10 CFR §50.55a
L-2005-168

Subject: Turkey Point Nuclear Plant Unit 3
Docket No. 50-250
10 CFR 50.55a Request for Temporary Non-Code Repair
Spent Fuel Pool Cooling Line (Request No. 6)

Florida Power & Light Letter No. L-2005-168
10 CFR 50.55a Request for Temporary Non-Code Repair
Spent Fuel Pool Cooling Line (Request No. 6)
Enclosure 1

Figure 1

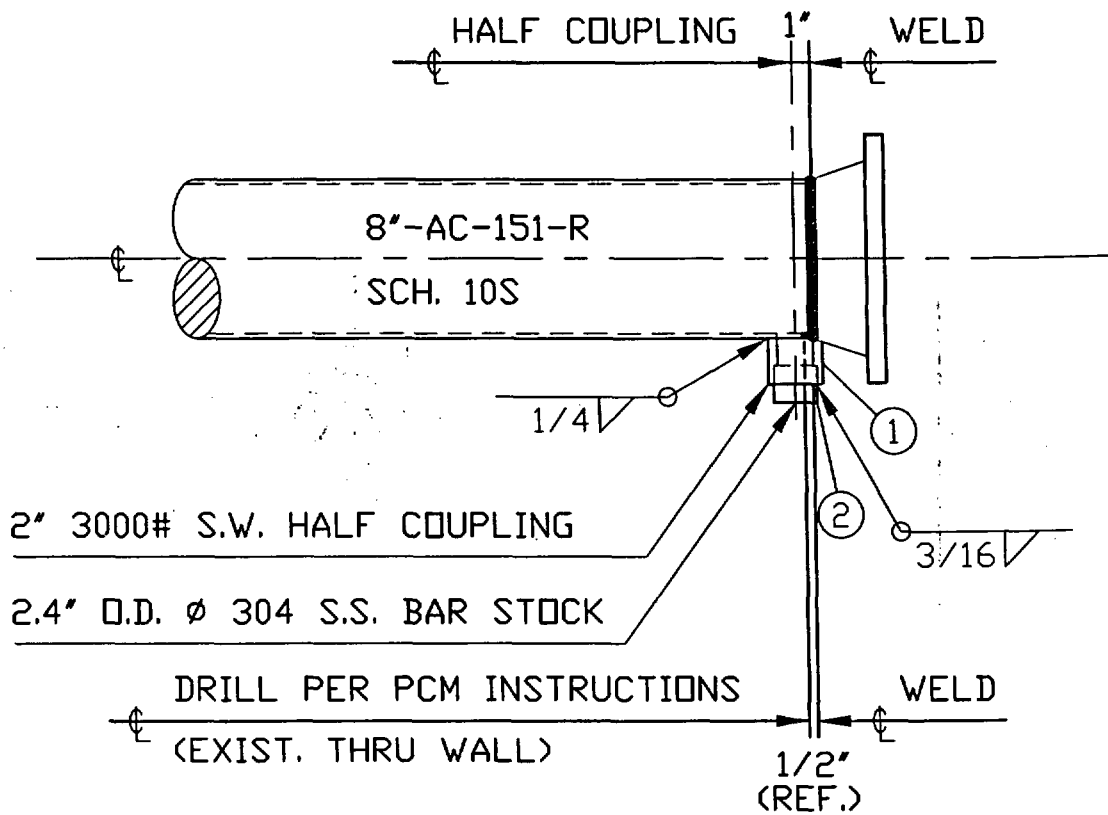
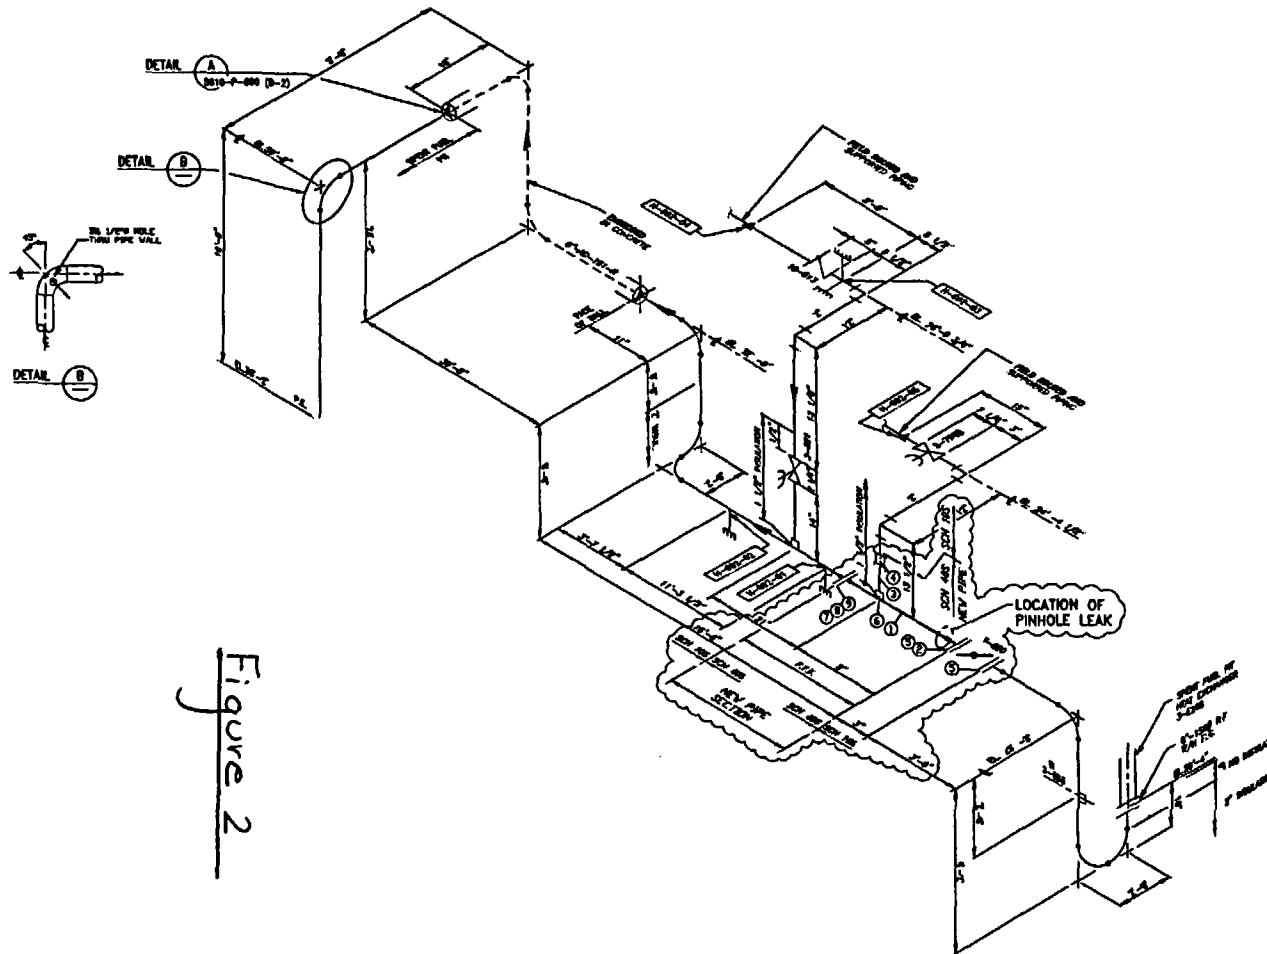
- 1.1 Option 1 (Figure 1) is to add a 2-inch diameter welded branch connection at the through-wall pinhole leak. The branch connection with a welded plug will act as the new pressure boundary at the attachment profile. All selected materials are compatible with SFP cooling system class and service. The time estimate for completion of this repair option is 20 hours.

Figure 3

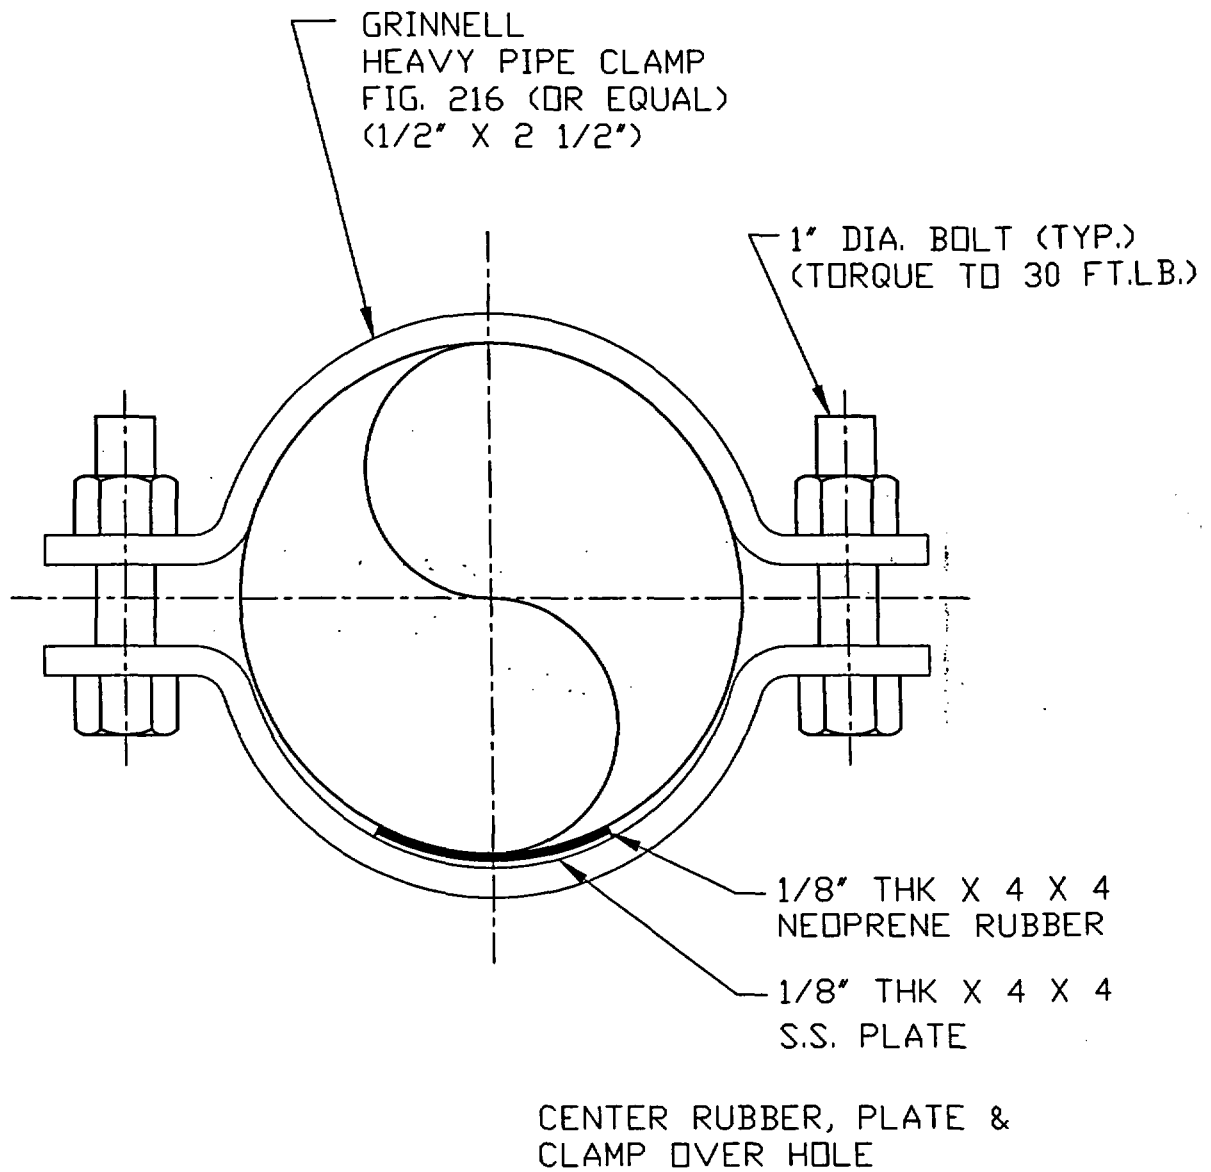
The selected design for the temporary non-Code repair contingency employs commercial grade materials able to withstand expected operating pressure and temperature conditions should a burn-through be created on the Schedule 10S 8-inch diameter stainless steel pipe during welding for the Code repair activity. The non-Code component is a simplified pipe clamp (Figure 3) designed to fit over a through-wall hole. The clamp and bolting material is robust and able to withstand any anticipated operating condition.

Figure 4: Model for Development of Allowable Non-Planar Flaws

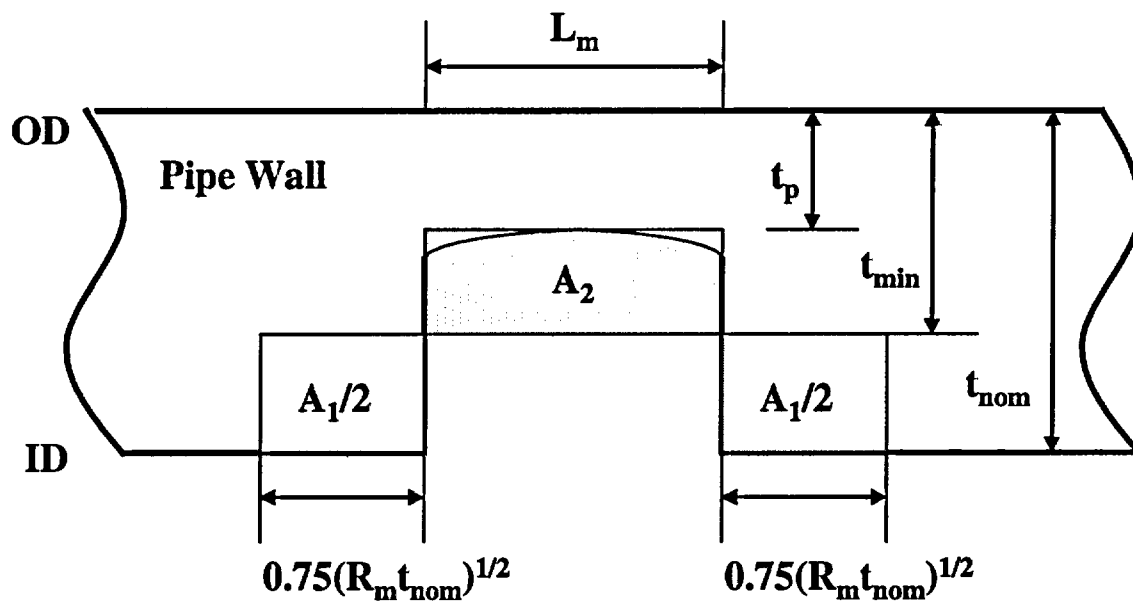
Guidance for evaluation of non-planar through-wall flaws is not provided in Code Case N-513. An alternate wall thinning criteria was developed using the "Limits of Reinforcement" rules in Paragraph NB-3640 of the ASME Code. The model used is illustrated in Figure 4.

Referring to Figure 4, Area A₁ (which is between the thinned area and the limits of reinforcement) should be balanced by Area A₂ (which is within the thinned area) in which case the following equation can be written:

Figure 5: Allowable Non-Planar Flaws for Various Nominal Wall Thicknesses

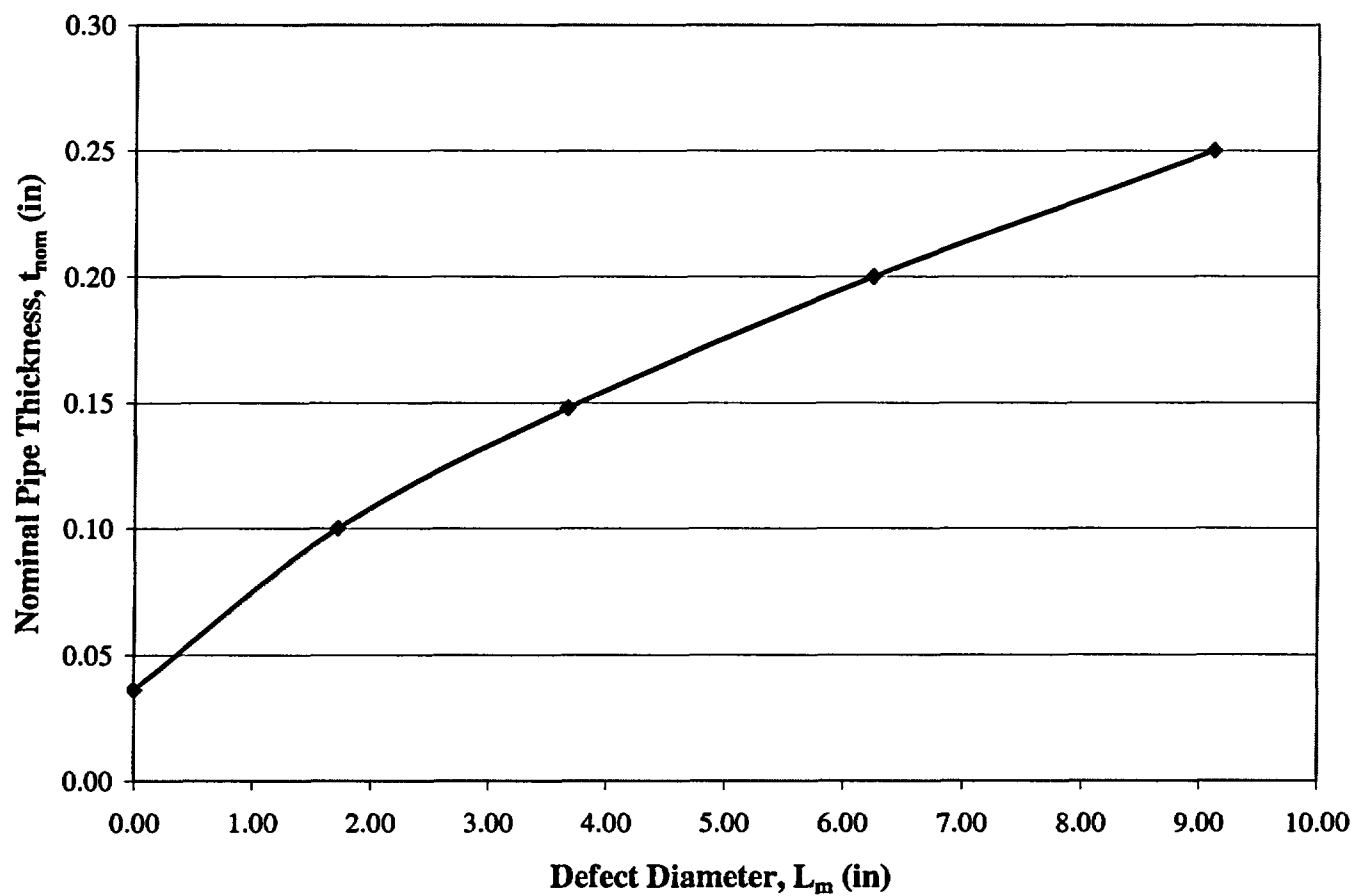
By setting $t_p = 0$ in Equation 2 (through-wall pit), the allowable hole diameter may be determined for a range of nominal pipe wall thicknesses (see Figure 5). It can be seen that through-wall pit sizes up to approximately 3.65 inches in diameter can be tolerated for a nominal pipe thickness of 0.148 inch without exceeding ASME Code margins. This is much greater than the assumed flaw size.
